**Subject: NEXTERA BLYTHE SOLAR ENERGY CENTER LLC'S RESPONSE TO
CEC STAFF DATA REQUEST SET 1 (1-19)
BLYTHE SOLAR POWER PROJECT AMENDMENT
DOCKET NO. (09-AFC-6C)**

BLYTHE SOLAR POWER PROJECT (09-AFC-6C)

RESPONSES TO DATA REQUESTS – SET 1

ATTACHMENT DR 5
MAP OF VEGETATION COMMUNITIES

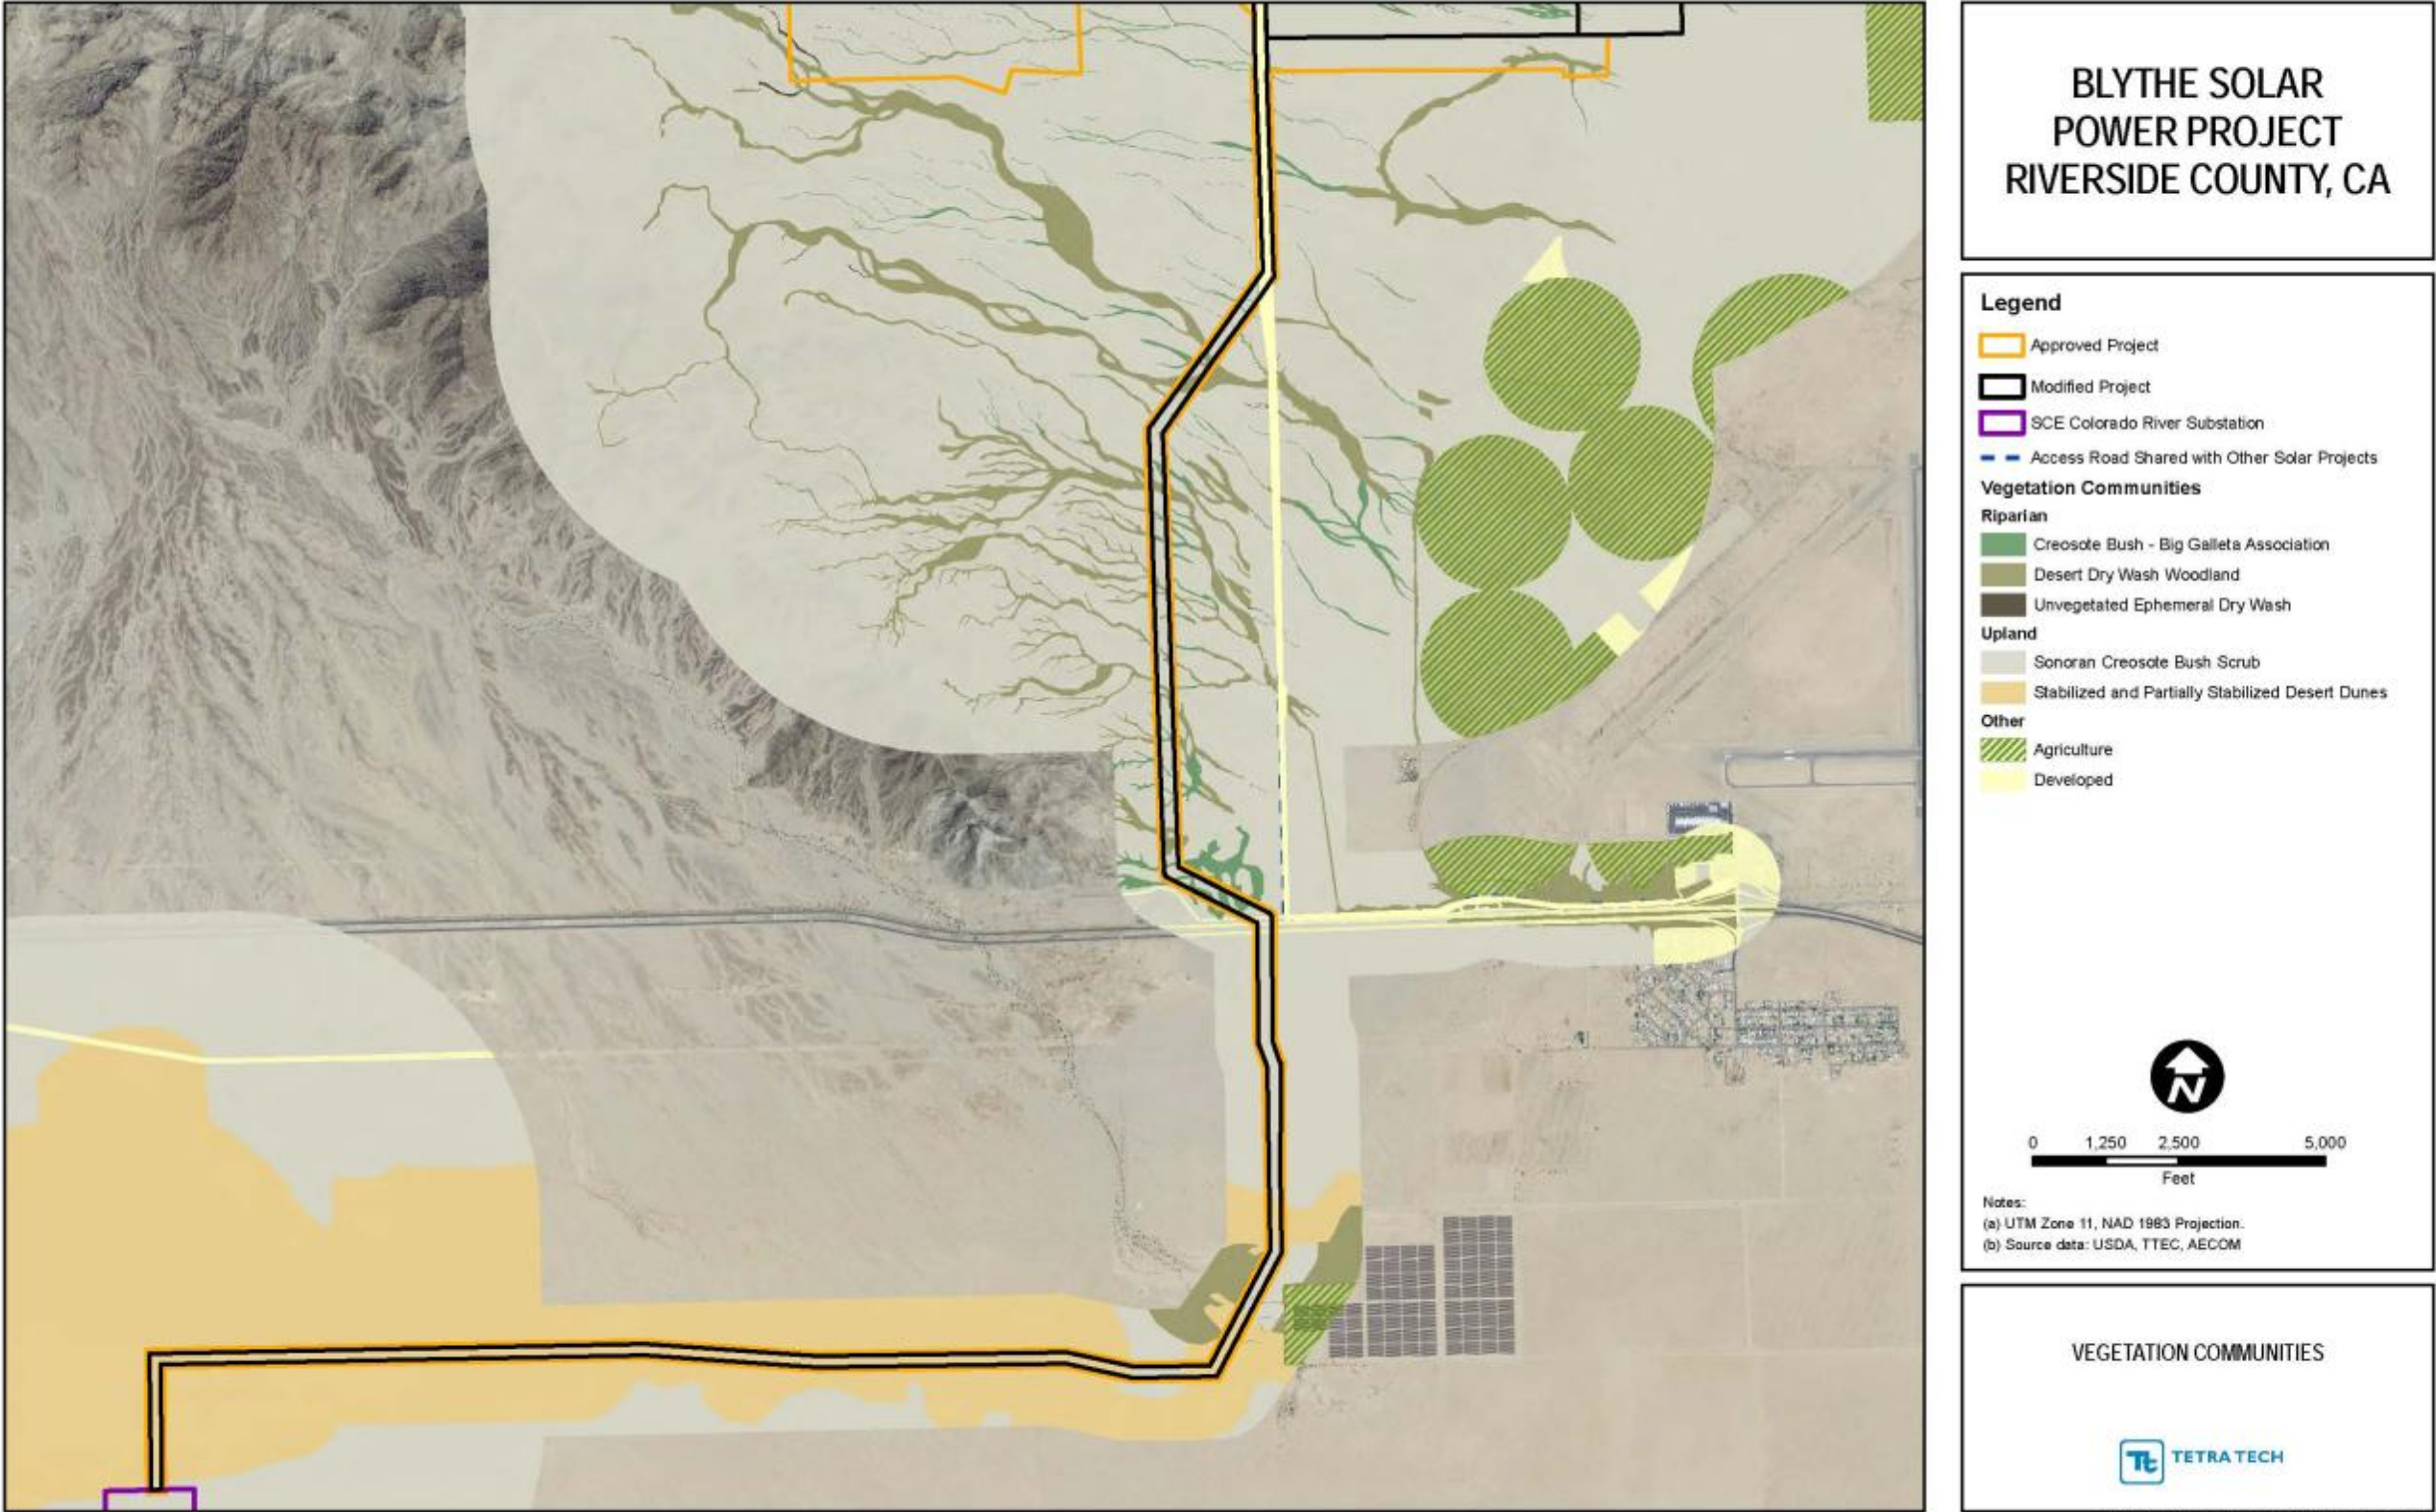
5. Map of Vegetation Communities. Please provide a figure of the upland vegetation and other vegetation types for the approved project with an overlay of the modified project boundaries. Please also provide the electronic files for all known vegetation communities as shape or geodatabase files.

Attachment DR 5 provides the requested information. A CD containing the GIS files has been provided with this Data Response.

**MAP OF EPHEMERAL DRAINAGES
(STATE JURISDICTIONAL WATERS)**

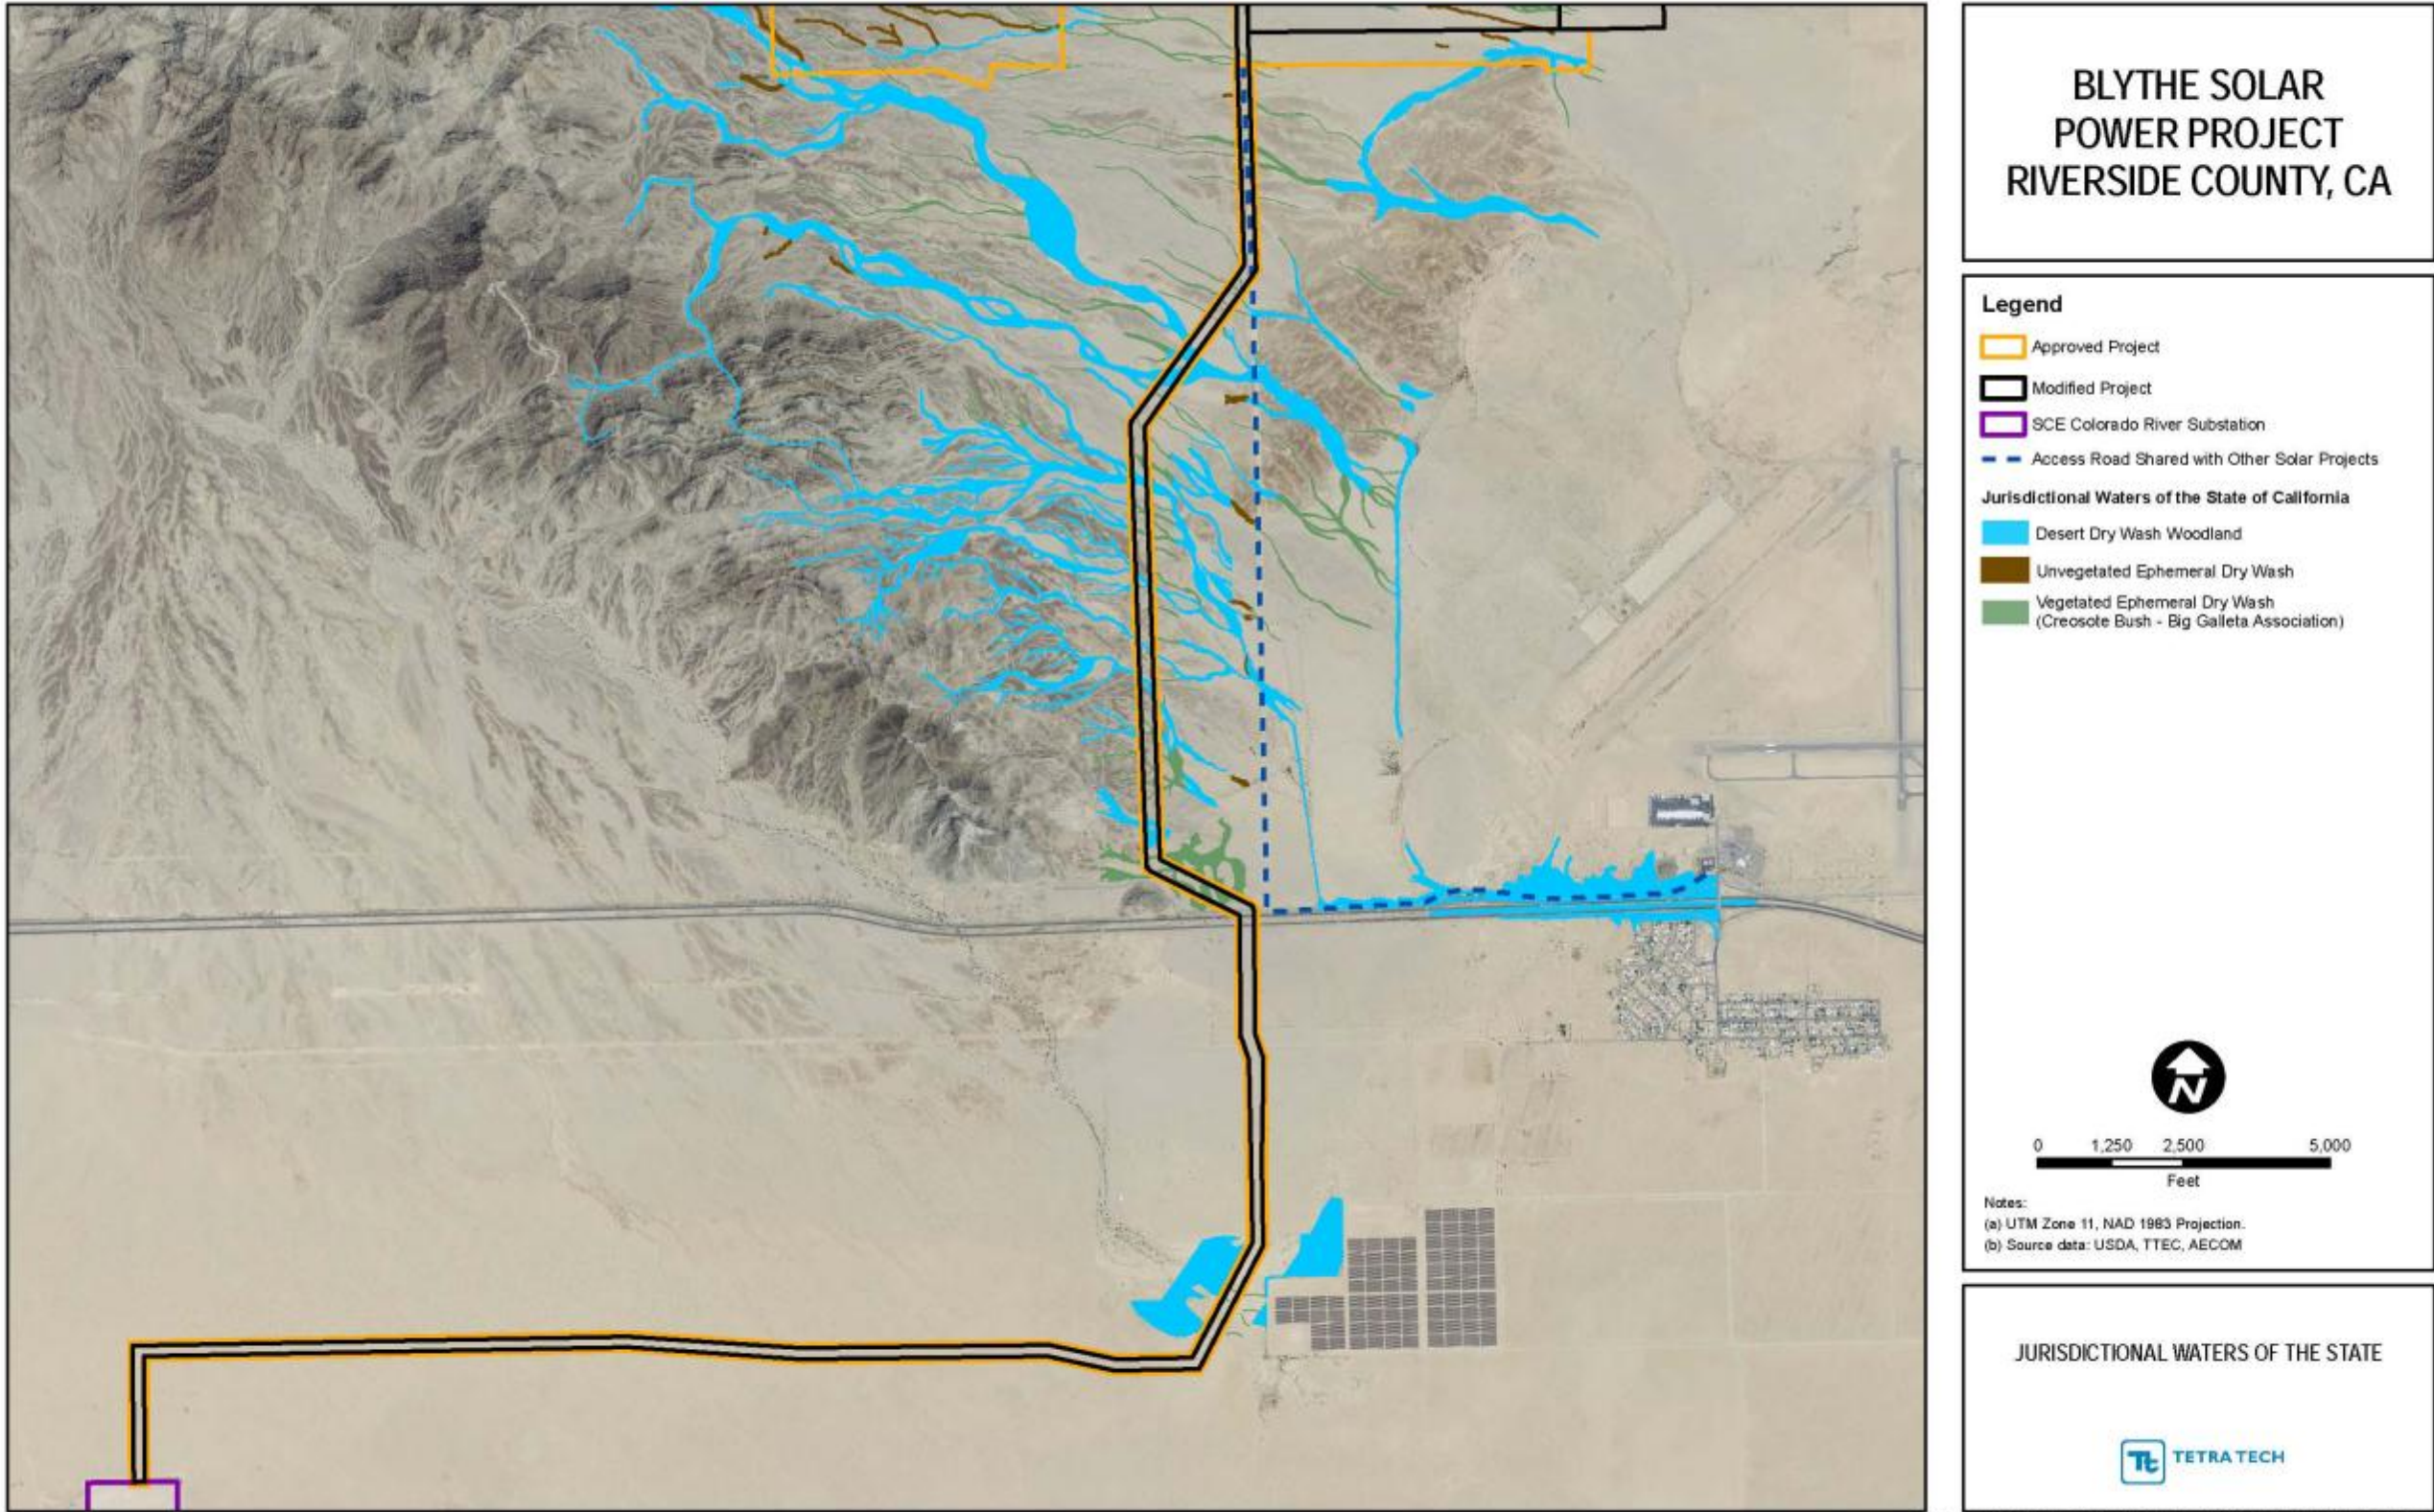
6. Map of Ephemeral Drainages (State Jurisdictional Waters). Please provide a figure of all the ephemeral drainages (state jurisdictional waters) with an overlay of the modified project boundaries. Please also provide the electronic files for all known ephemeral drainage locations as shape or geodatabase files.

Attachment DR 6 provides the requested information. A CD containing the GIS files has been provided with this Data Response.
